ARCHITECTURAL REVIEW BOARD MEETING

PLANNING AND ZONING COMMISSION CASE MEMO

TO: Planning and Zoning Commission
DATE: September 13, 2022
APPLICANT: Bob Pruett; *Urban Structure*
CASE NUMBER: SP2022-044; *Site Plan for Advantage Storage*

exterior elevations - bldg's b, c, & d

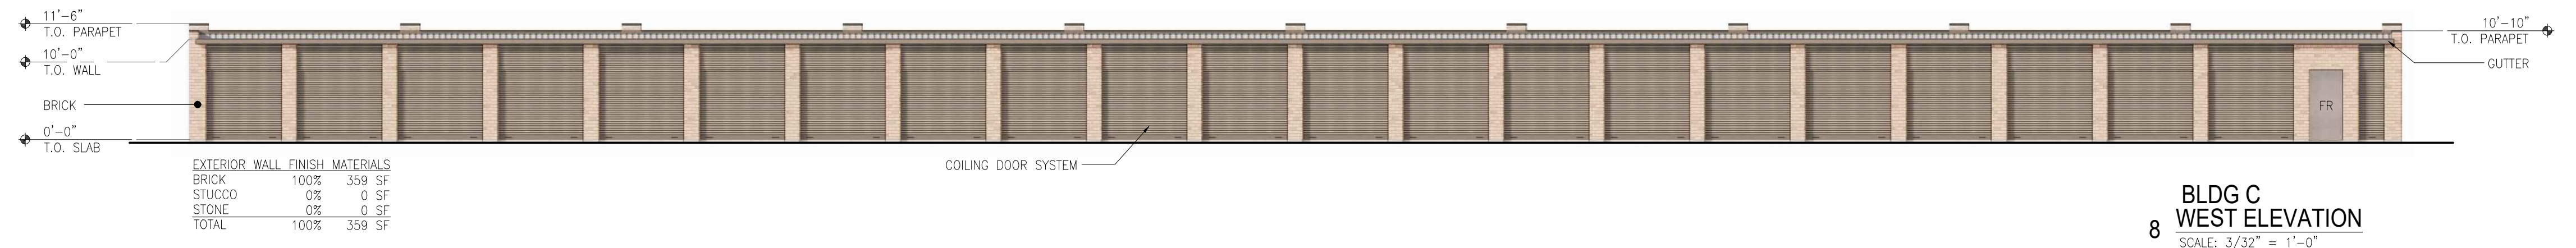
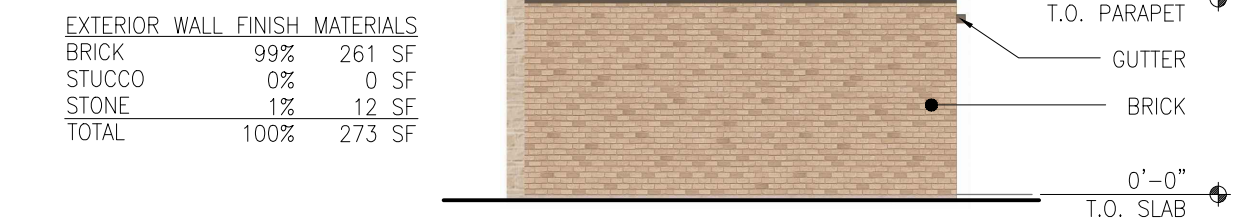
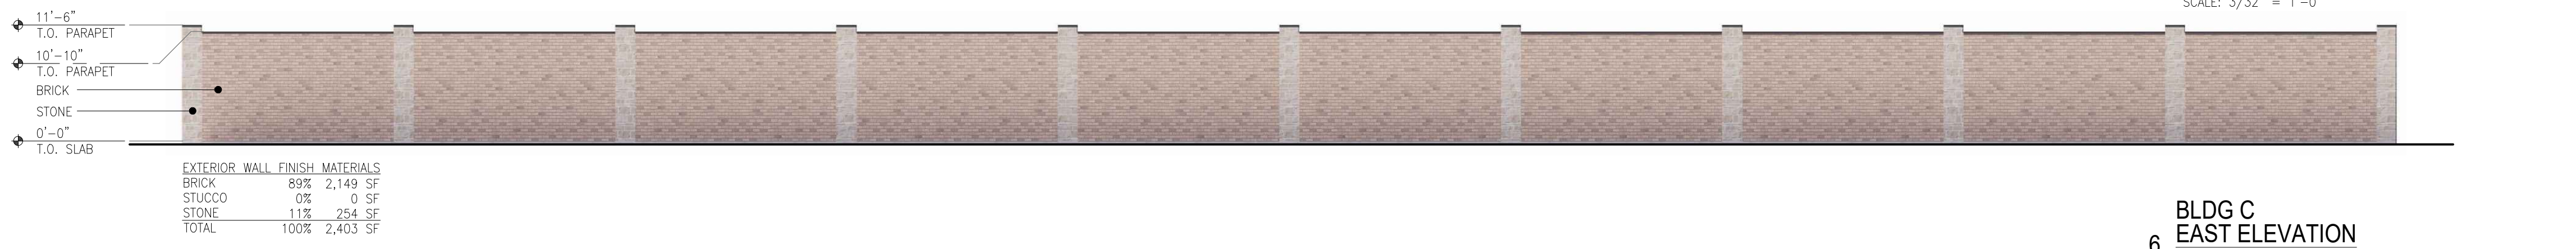
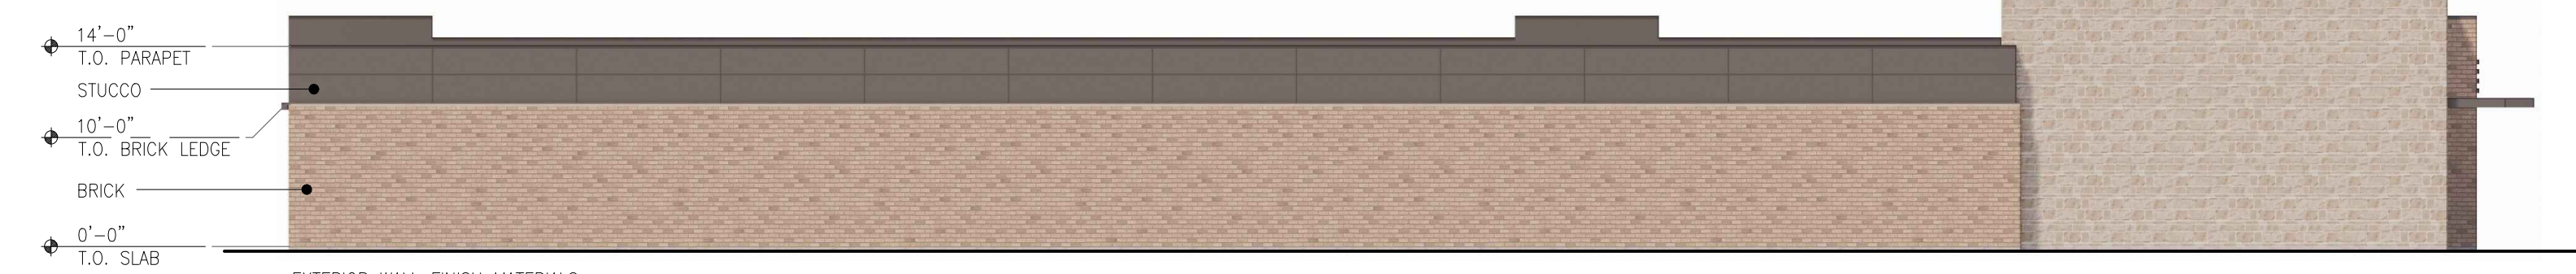
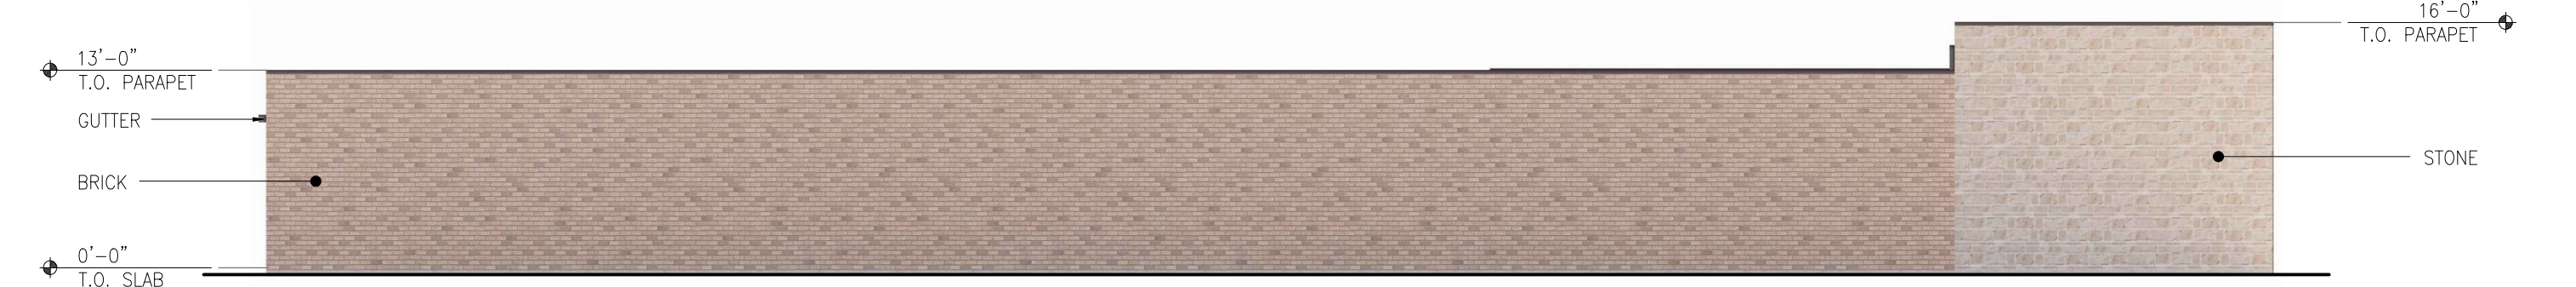
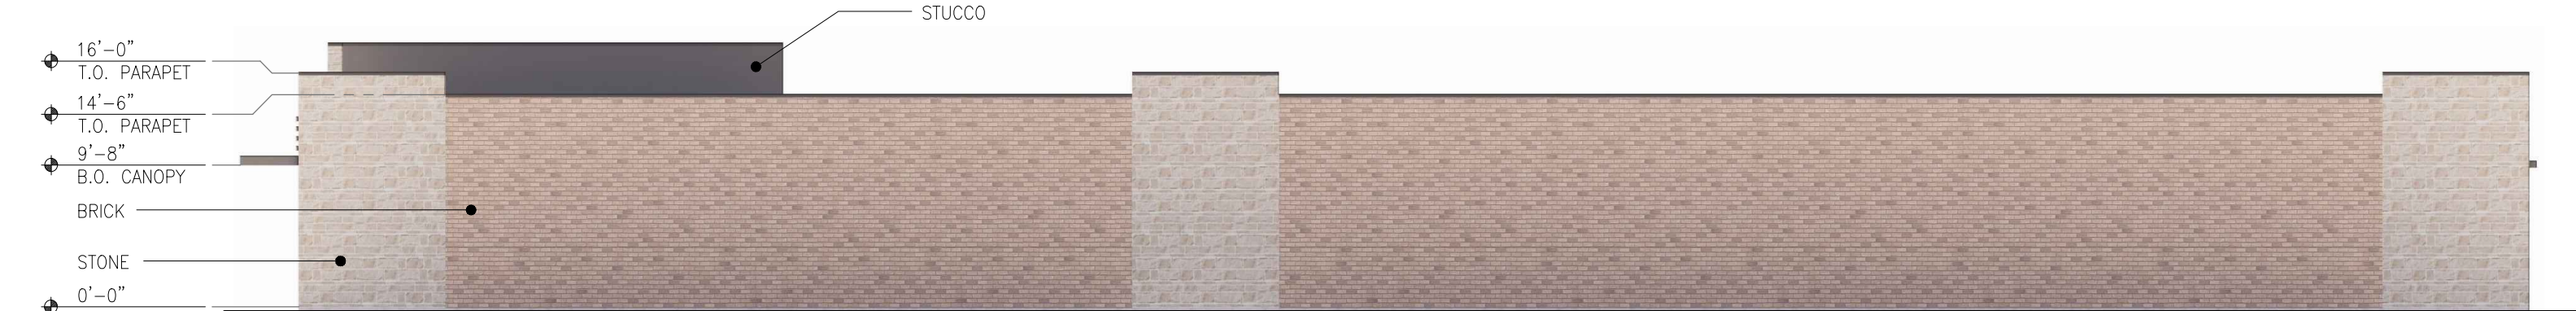
(1) Architectural Standards.

- (a) Materials and Masonry Composition. According to Subsection 06.02(C)(1), Article 05, of the *General Overlay District Development Standards* of the Unified Development Code (UDC), “(e)ach exterior wall of a building’s façade shall consist of a minimum of 90% *Primary Materials* and/or a maximum of 10% *Secondary Materials* -- *excluding doors and windows.*” In this case, the applicant is requesting contains less than 90% *Primary Materials* and more than 10% *Secondary Materials*. *Therefore, this will require approval of a variance from the Planning and Zoning Commission.*

- (b) Stone. According to Subsection 06.02(C)(1)(a)(1), of Article 05, of the *General Overlay District Development Standards* of the Unified Development Code (UDC), “(a) minimum of 20% natural or quarried stone is required on all building façades...” In this case, the applicant is requesting a minimum of five (5) percent stone on the facades that stone is used and no stone on the west elevation of *Building C*, which -- *staff should note* -- will not be visible from any view around the site since the facility is only open to customers. *This will still require approval of a variance from the Planning and Zoning Commission.*

- (c) Four-Sided Architecture. According to Subsection 06.02(C)(5), of Article 05, of the *General Overlay District Development Standards* of the Unified Development Code (UDC), “(a)ll buildings shall be architecturally finished on all four (4) sides utilizing the same materials, detailing, articulation and features. In addition, a minimum of one (1) row of trees (i.e. four [4] or more accent or canopy trees) shall be planted along perimeter of the subject property to the rear of the building.” In this case, the proposed buildings are not architecturally finished on all four (4) sides. *This will require approval of a variance from the Planning and Zoning Commission.*

- (d) Roof Design Standards. According to Subsection 06.02(C)(2), of Article 05, of the *General Overlay District Development Standards* of the Unified Development Code (UDC), “(a)ll structures that have a building footprint of less than 6,000 SF shall be constructed with a pitched roof.” In this case, the proposed *Building C* is a total of 4,000 SF and has a flat roof design. *This will require approval of a variance from the Planning and Zoning Commission.*

On August 30, the Architecture Review Board (ARB) reviewed the proposed building elevations, and requested changes from the applicant. Specifically, the ARB requested that the applicant finish the parapets on both sides and make sure the RTUs are screened from any view. The applicant has provided updated building elevations that generally conform to the ARB’s request. These will be reviewed by the ARB at the meeting on September 13, 2022.

PHOTOMETRIC PLAN
 SCALE: 1/4" = 1'-0"

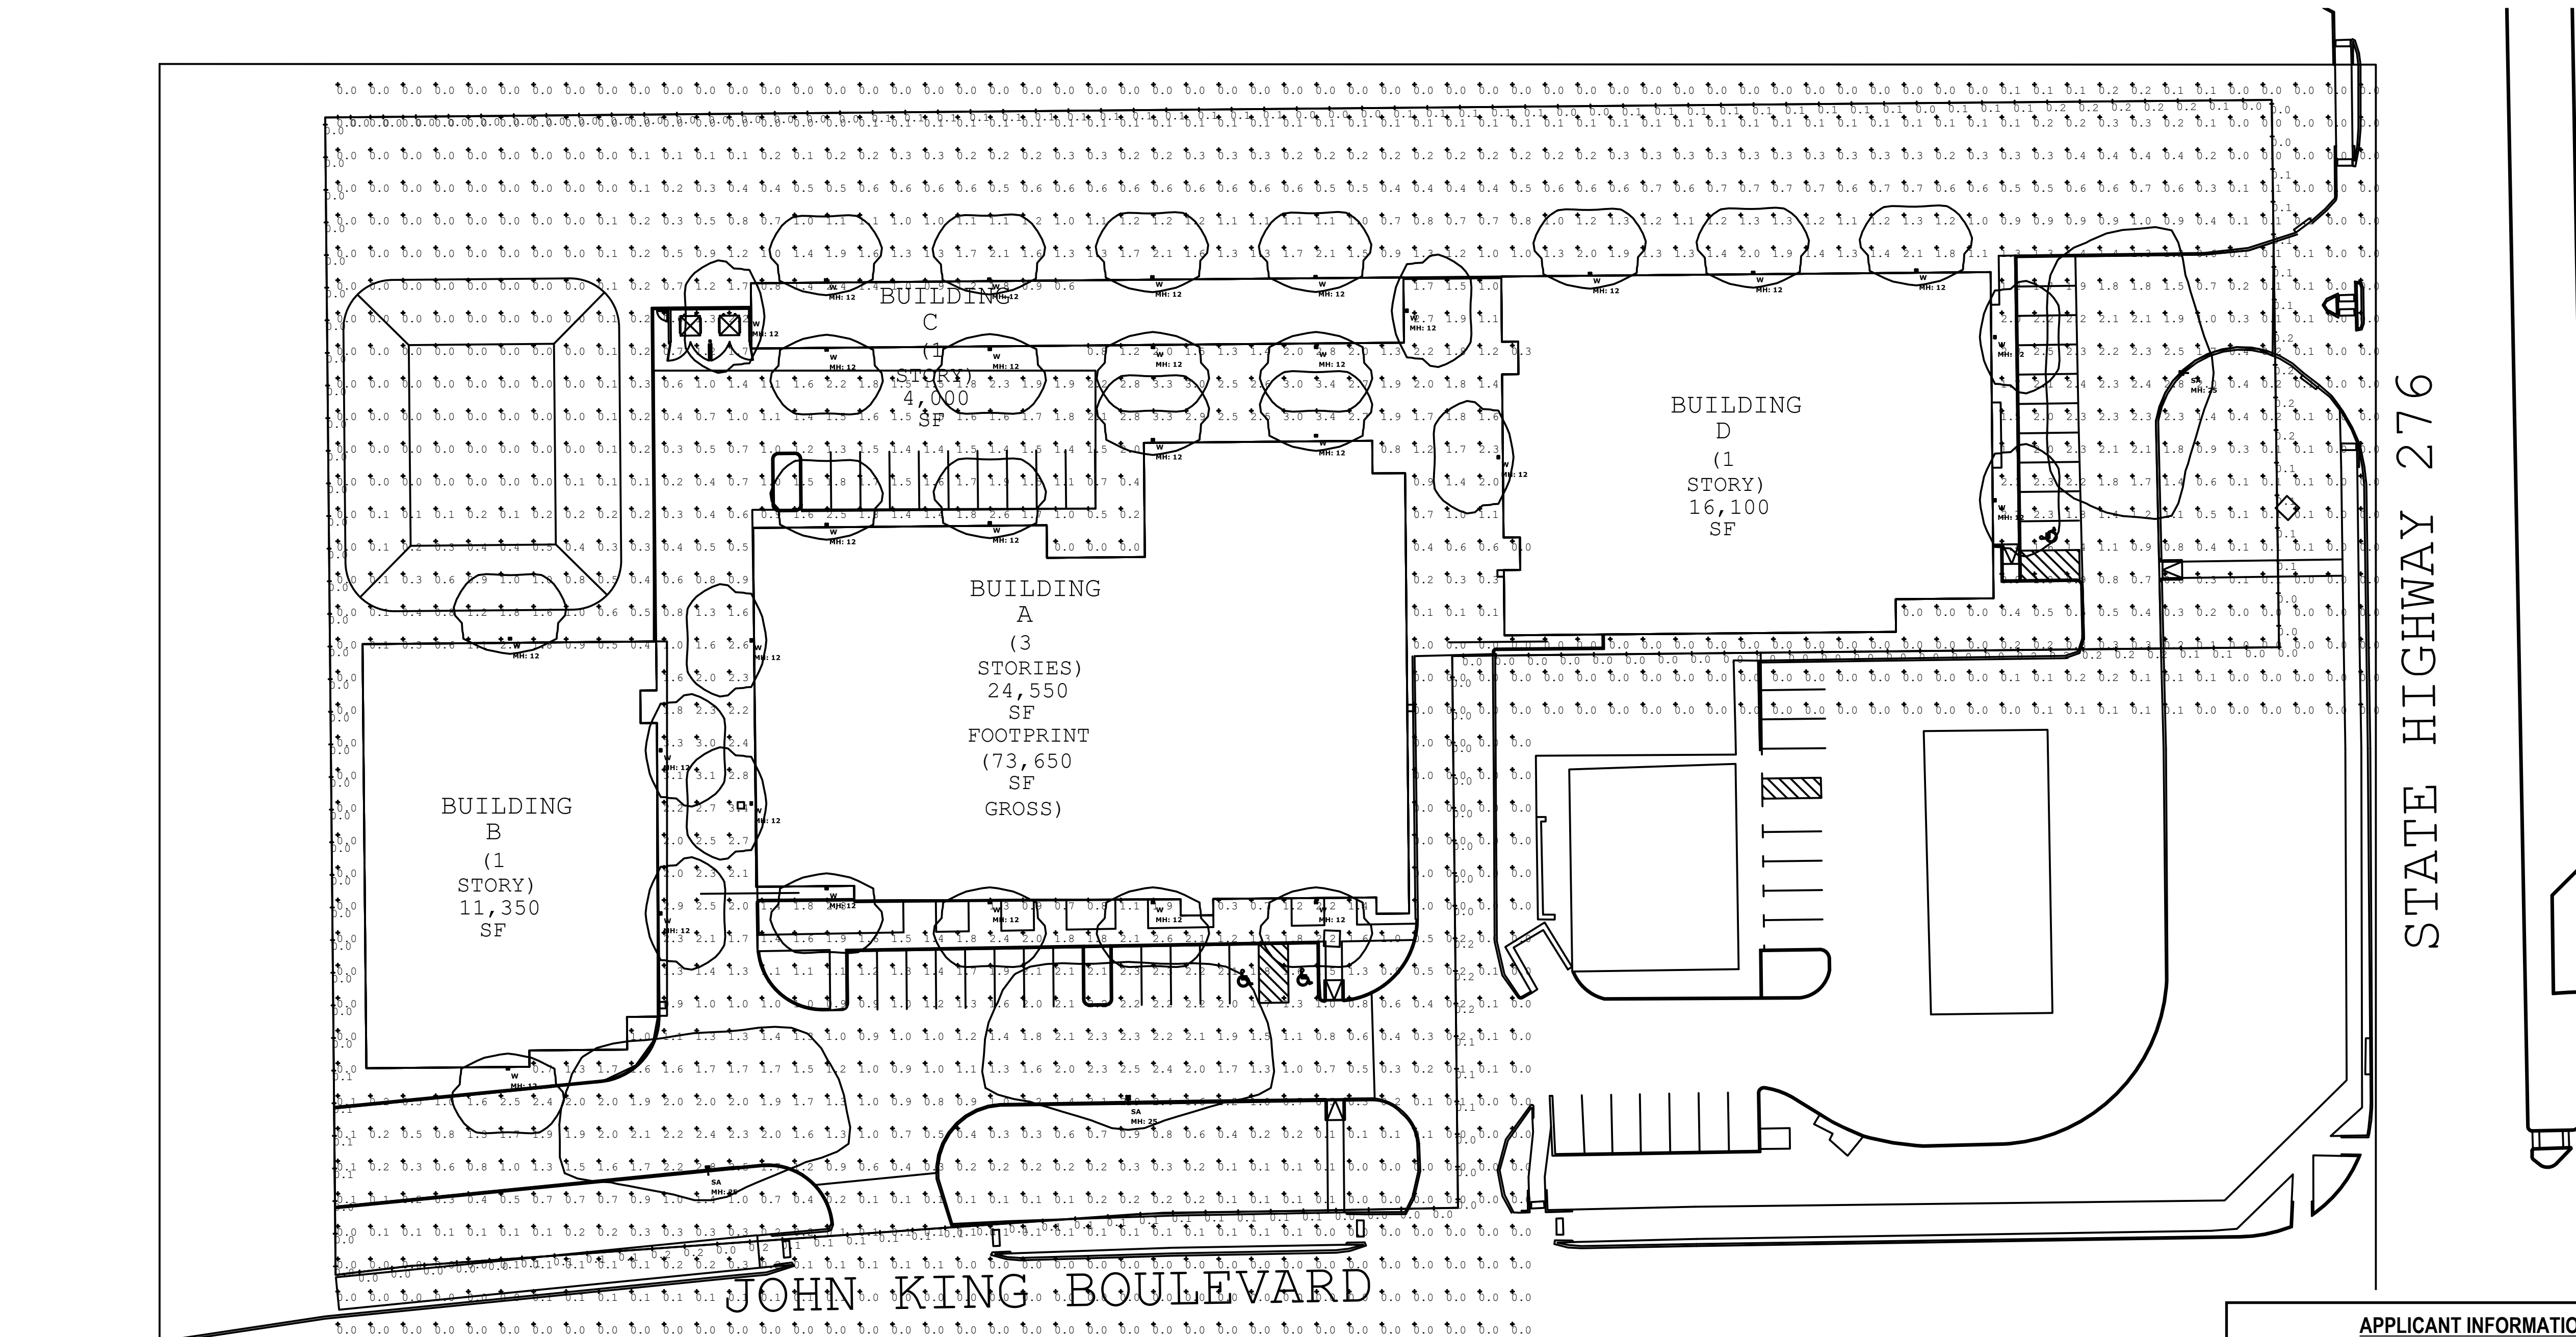
- (1) All staff comments provided by the Planning, Engineering and Fire Department must be addressed prior to the submittal of engineering plans.
- (2) The applicant provide an updated Photometric Plan indicating a maximum 20-foot light pole in conformance with the *Conditional Land Use Standards* of the UDC.
- (3) If Planning and Zoning recommends approval of the exception to the *Building Height* in the *Conditional Use Standards*, the exception will need to be approved through City Council.
- (4) Any construction resulting from the approval of this Site Plan shall conform to the requirements set forth by the Unified Development Code (UDC), the International Building Code (IBC), the Rockwall Municipal Code of Ordinances, city adopted engineering and fire codes and with all other applicable regulatory requirements administered and/or enforced by the state and federal government.
